**Dennis Family Corporation
Submission to Draft Casey Fields South (Employment) & Devon Meadows PSP
Amendment C295case to the Casey Planning Scheme**

The following letter sets out submissions by DFC in response to proposed Amendment C295 to the Casey Planning Scheme – the Casey Fields South (Employment) & Devon Meadows (CFS&DM) PSP.

Figure 1 - Casey Amendment C295case – Public Acquisition Overlay – Schedule 4 (VPA)

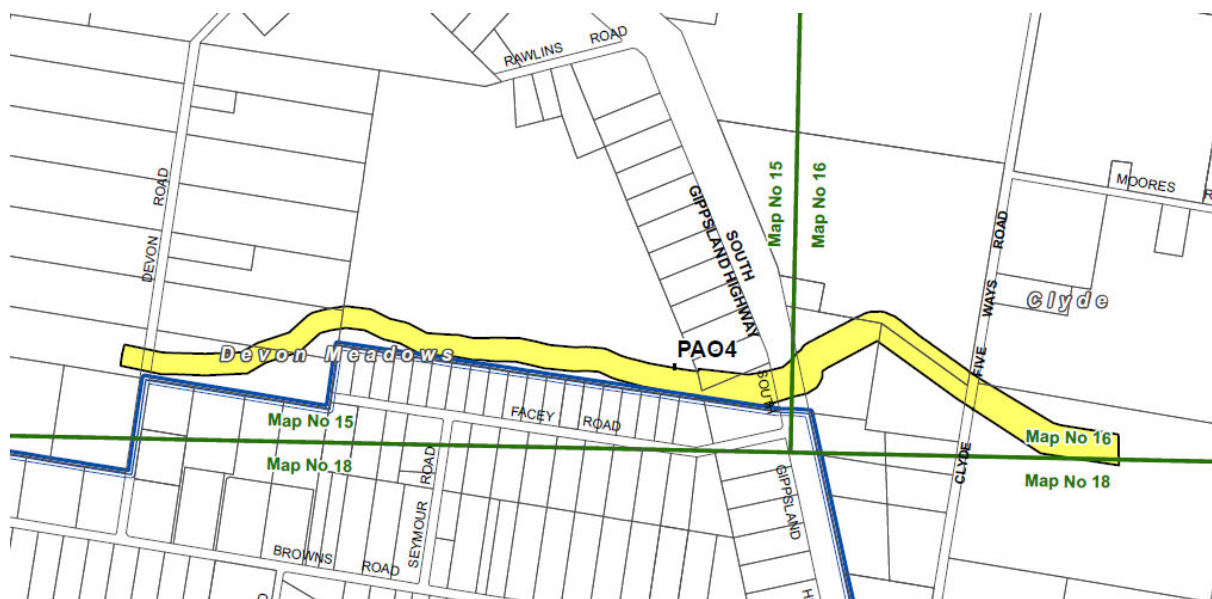
The draft PAO – Schedule 4 (PAO4) shows that the proposed diversion waterway extends significantly east beyond the Clyde Fiveways Road and onto land within the Clyde South PSP precinct area (See Figure 1, below).

The diversion waterway thus moves stormwater flows from the south of the Devon Meadows PSP and into the Clyde South PSP precinct. The amendment documents are largely silent on how these flows are proposed to be conveyed and attenuated beyond the end of the PAO4 extent, however it seems clear that a retarding basin will need to be constructed somewhere near the southern boundary of the Clyde South PSP along Manks Road, prior to water discharging into the Westernport Green Wedge.

Submission 1: We request clarification of the full impacts of the proposed Clyde Five Ways Road Drainage Services Scheme (DSS) upon the Clyde South PSP.

Figure 2 - Appendix C – Preliminary concept drainage strategy plan - Figure C1 (Source: GHD Interim report – Casey Fields South (Employment) and Devon Meadows Precinct Structure Plan – Preliminary Concept Drainage Strategy, 21 February 2025).

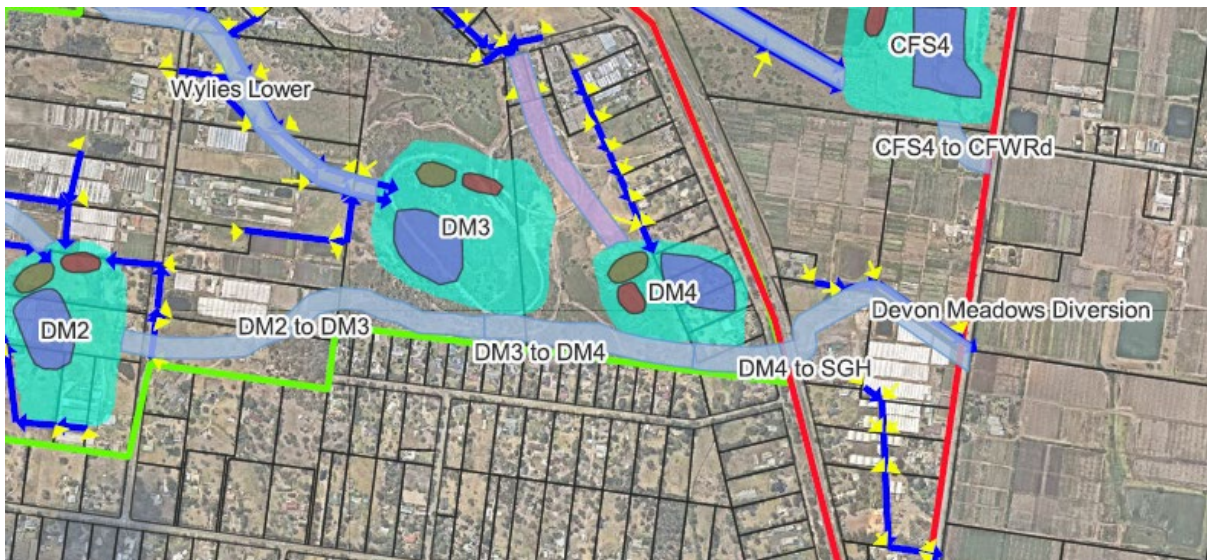
In fact, the PAO4 extends well beyond the waterway shown in the GHD concept drainage strategy plan upon which the drainage services scheme is based (See Figure 2, below).

The GHD report also suggests the potential need for additional land take within the future Clyde South PSP area to manage cumulative flood peaks within the proposed Clyde Five Ways Road Drainage Services Scheme (DSS). This scenario arises from the merging of two outfalls (O1 and O2) from the CFS&DM PSP east of the Clyde Fiveways Road, within the Clyde South precinct:

The reliance upon land within the Clyde South PSP to ameliorate stormwater flows from the CFS&DM PSP is concerning in the absence of a further information detailing how stormwater will be managed within the PSP. While Melbourne Water has agreed to fund additional works within the Clyde South precinct, including land acquisition associated with the PAO4, there remains a dearth of other information relating to implementation of the proposed drainage scheme. For example, it is unclear how the Clyde Five Ways Road Drainage Services Scheme (DSS) is going to operate to best practice standards in the interim, that is, until resolution of the above issues within the Clyde South PSP area.

Figure 3 – PSP Plan 9 Infrastructure and Development Staging (VPA) – highlights added

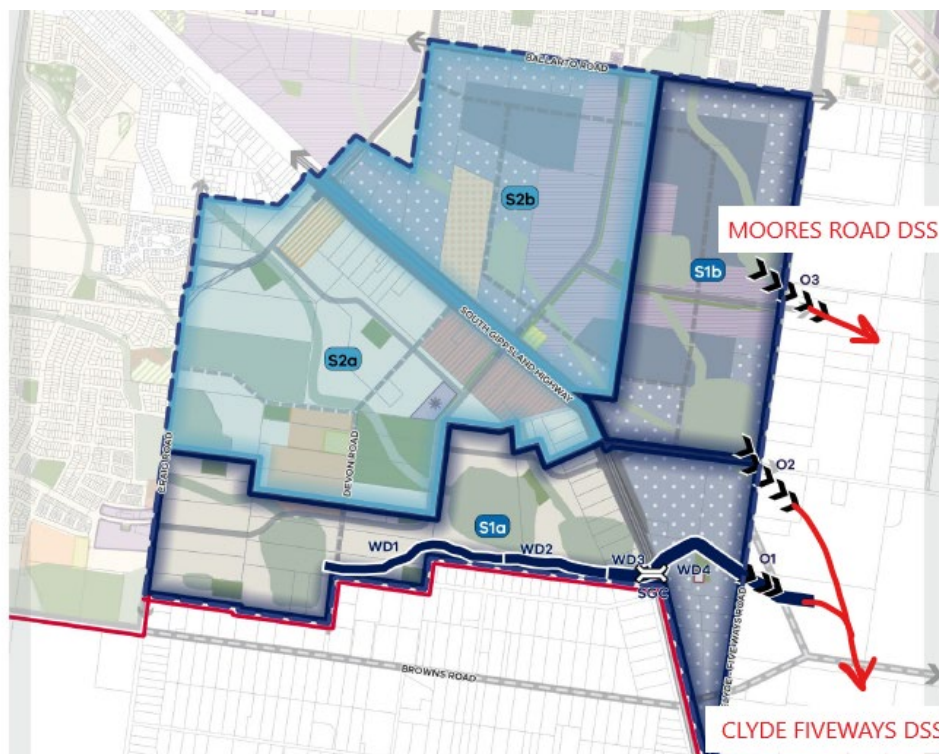
We are concerned that the catch-all approach taken to provision of those items of infrastructure identified in Table 8 and Plan 9 conflates drainage infrastructure across two separate and independent DSS', namely the Clyde Five Ways Road DSS and the Moores Road DSS. Project items O2 and O3 are identified in Stage S1b but outfall into the separate schemes (See Figure 3).

This will effectively mean that land within the Moores Road DSS in Stage S1b will not be able to develop until all infrastructure items identified in Table 8 are delivered. However, this land only requires construction of outfall O3 (and other upstream drainage infrastructure in the Moores Road DSS) to develop. This highlights difficulties in imposing such an inflexible staging regime over the PSP.

While we acknowledge the importance of ensuring the timely delivery of key enabling drainage infrastructure identified in Plan 9, we fear that the imposition of such a universal and inflexible sequencing of stages and infrastructure projects, particularly given the land fragmentation of the PSP, may inadvertently stall all development in the PSP.

Submission 2: We request greater flexibility be written into the infrastructure and development staging requirements in Section 7.3 of the CFS&DM PSP. Requirements should be revised to permit some flexibility in the order of delivery of the identified staging infrastructure where it can be demonstrated that an alternative deployment of key infrastructure can meet DSS outcomes, to the satisfaction of the relevant water authority.
